Addendum No. 1

Subject: Bid B-061 C of 2018/19 for General Contractor Services on Building Envelope Project

Location: John F. Hartranft School

DRAWING TITLE: **ROOF PLAN**

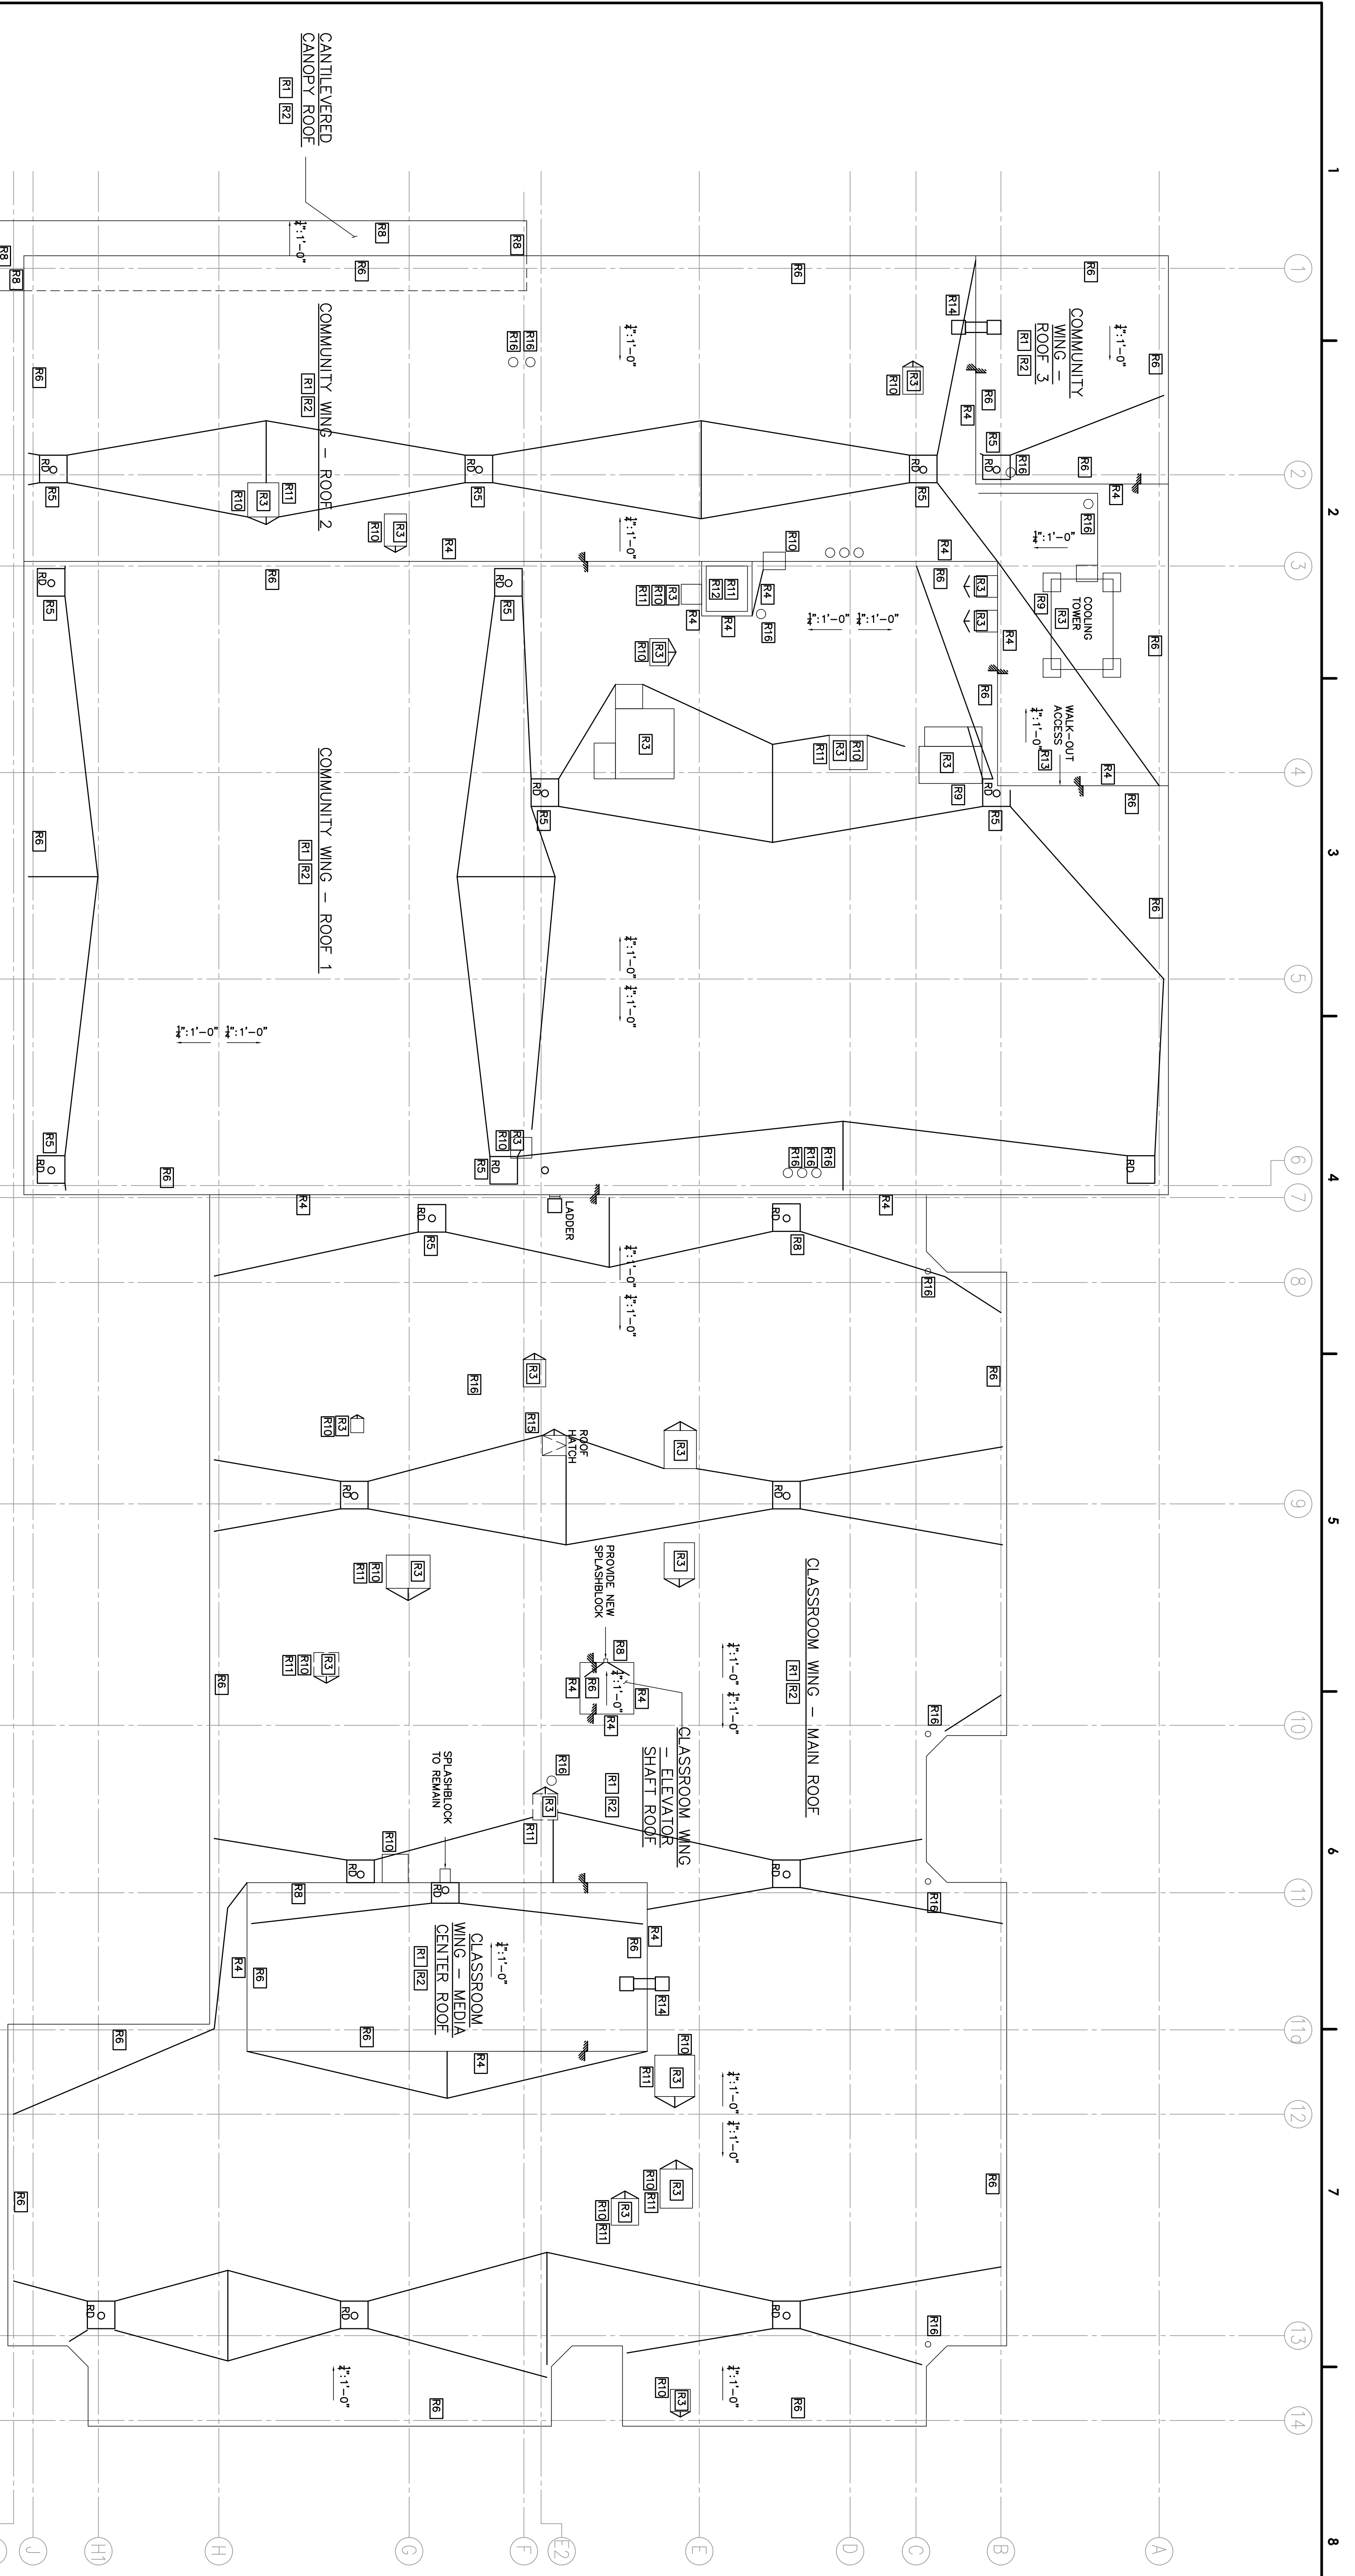
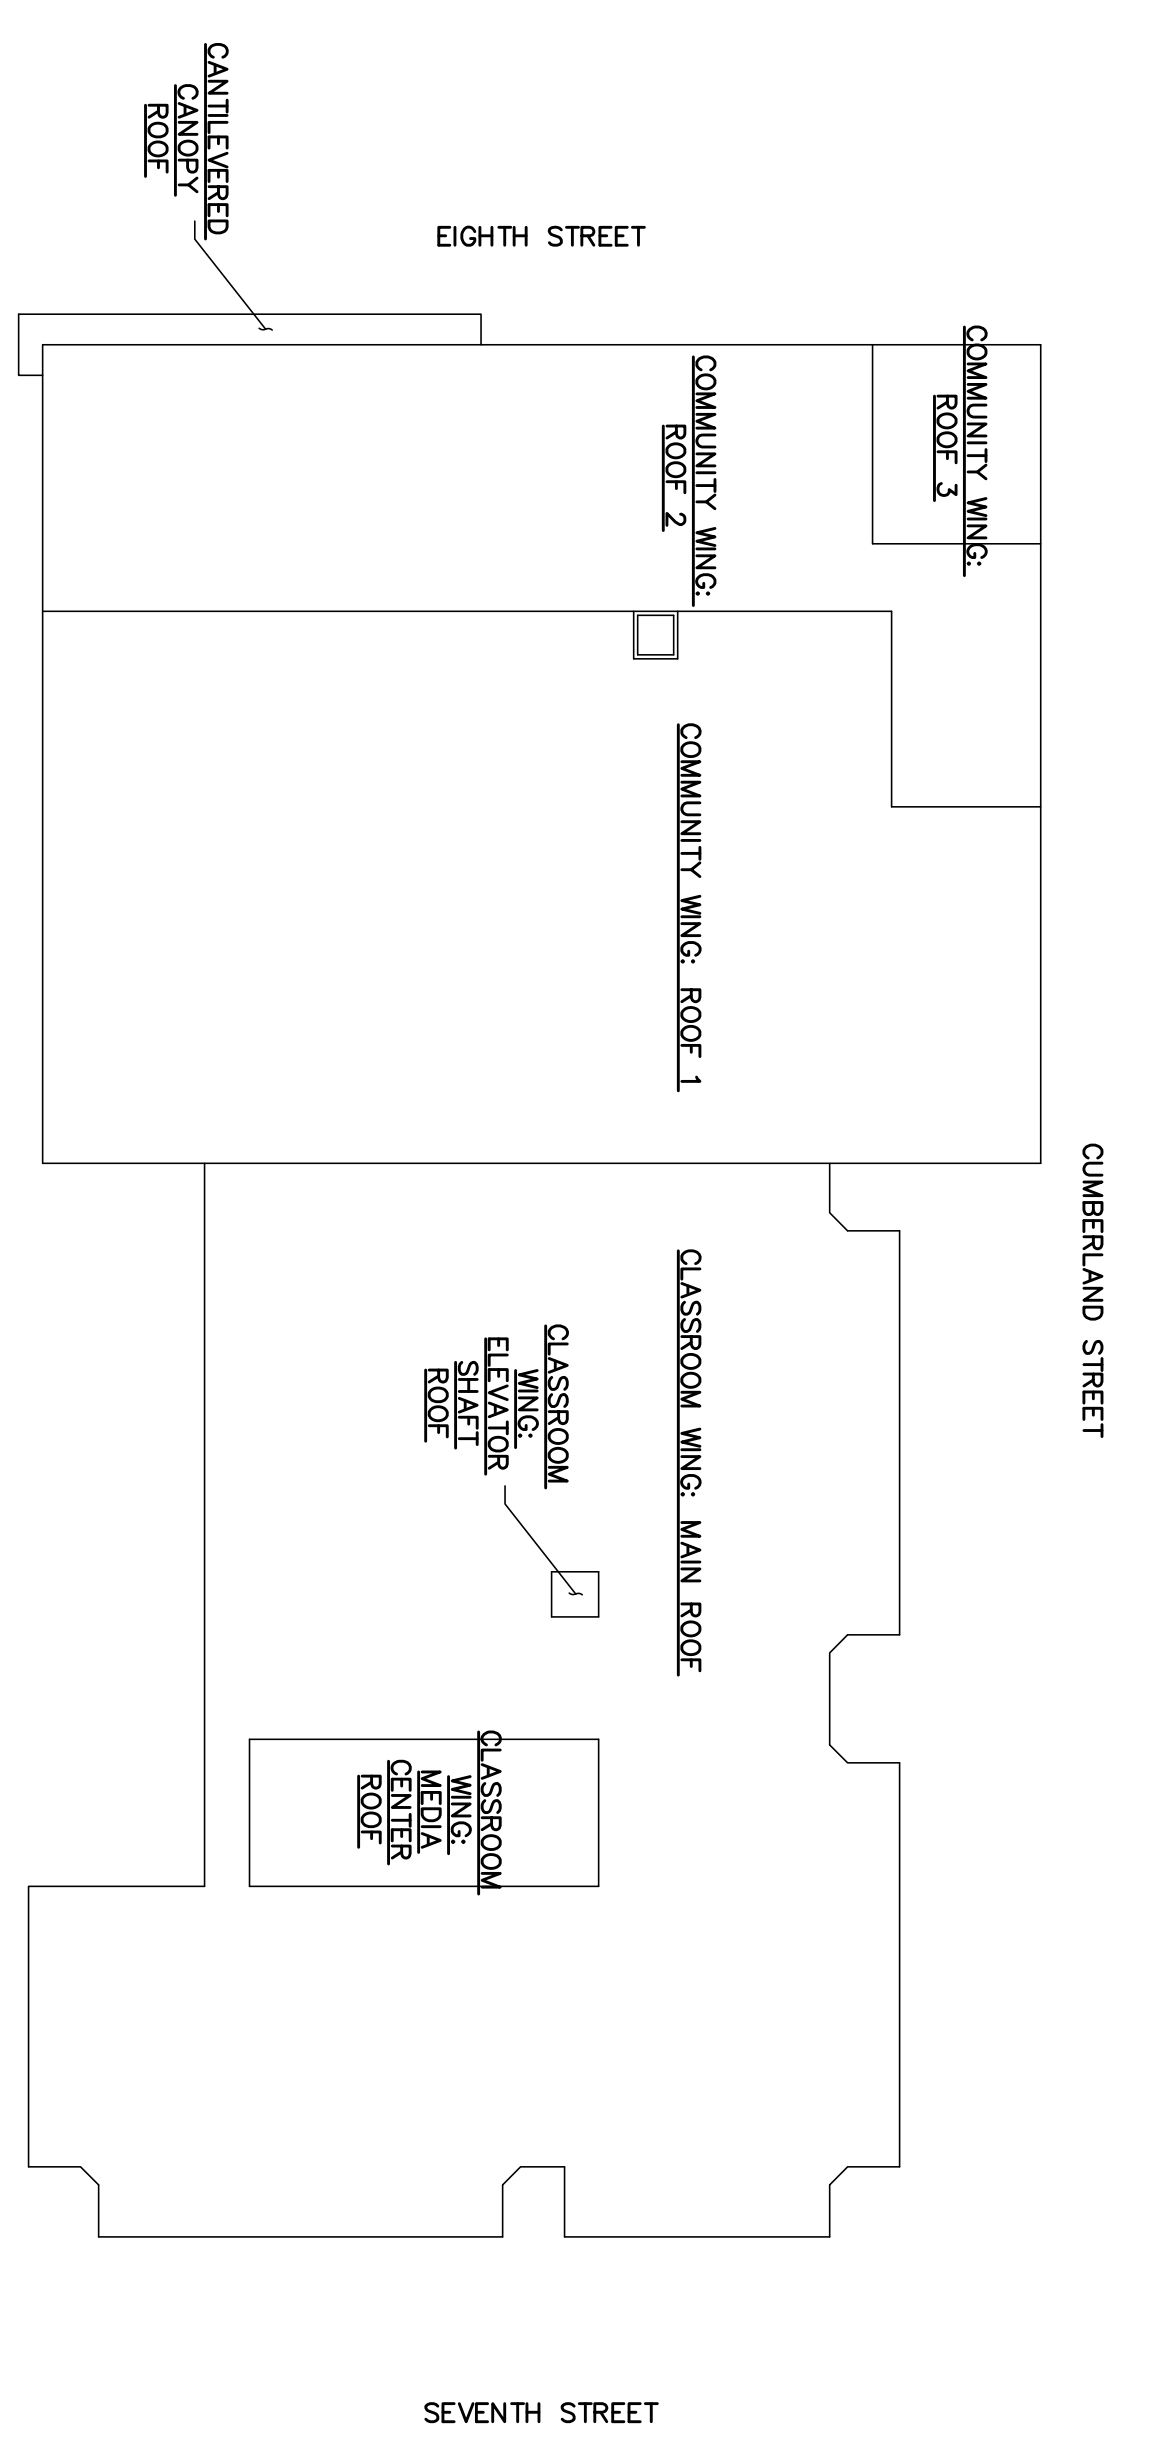
2. Under the proposed conditions chart it mentions the insulation, and existing membrane to remain, but the drawings and specs show a tear off down to the concrete deck. Which are we to follow?

All roofs will be torn off down to concrete deck. New insulation and new roofing shall be installed per drawing R-100 and specifications. Sheet R-101 has been revised in agreement with this (see attached).
